Core Bus Corridor 12: Rathfarnham

17th April 2020

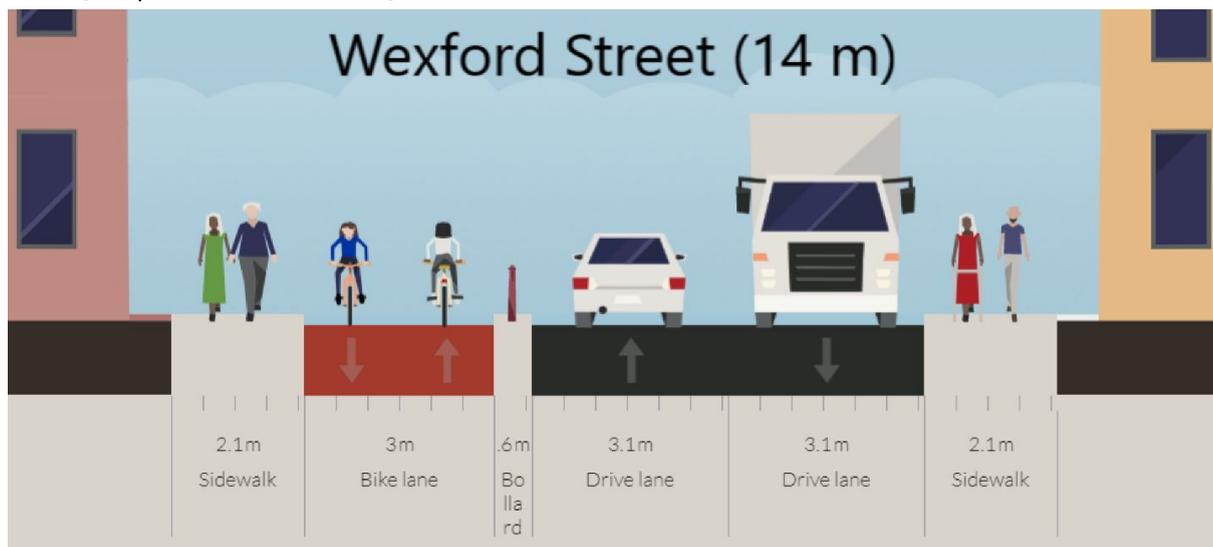
There is no outbound cycle path proposed here, and the inbound cycle path is only 1.5 m wide. From the traffic counts, it is clear that pedestrians, cyclists and bus users vastly outnumber people in private cars. Two right turn lanes is completely unreasonable given the lack of space for people cycling here. We would like to see one of the right turn lanes removed and for that space to be re-allocated for people walking and cycling.

Possible layout for George's Street/Aungier Street with a 9.5 m wide carriageway, and 2.1 m wide loading bay

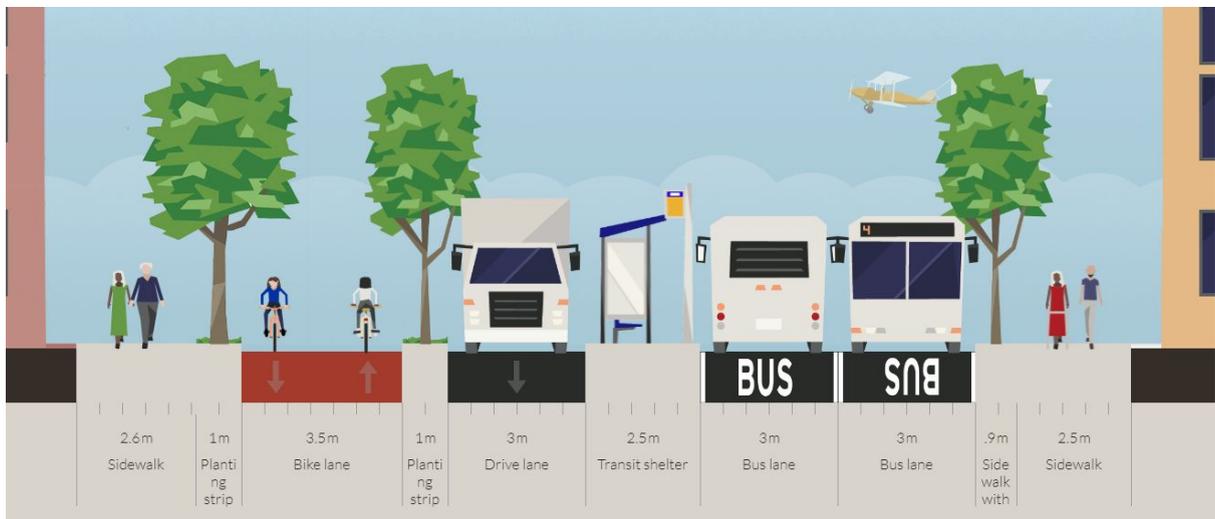
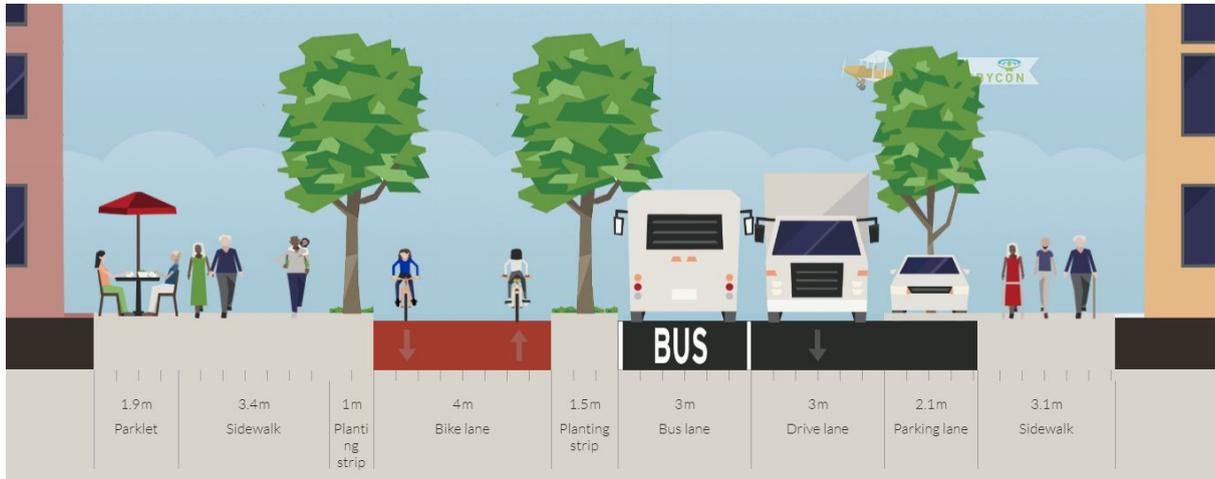
We are also concerned about conflicts between cyclists and loading/parked vehicles, particularly the fact that the cycle lane goes straight through loading bays, making it completely unusable when the loading bay is occupied.

Our preference would be to install a 3-4 m wide bidirectional cycle path on one side of the road, with all the loading bays on the other side. This would eliminate all conflicts with loading vehicles, and discourage illegal parking in the cycle path.

Even at the narrowest section of Wexford Street, the road is 14 m wide, which is enough space for this design, as shown below.

Other than this pinch point, the road north of Camden Street is generally between 16.5 and 20 m wide. This means that there is more than enough space for wide cycle paths and footpaths, trees, buffers, island bus stops, and loading bays.

Same road width as above, but with a 2.6 m wide island bus stop.

Where there are no bus stops or loading bays, there is space for trees, benches, bike parking, and a wider cycle path.
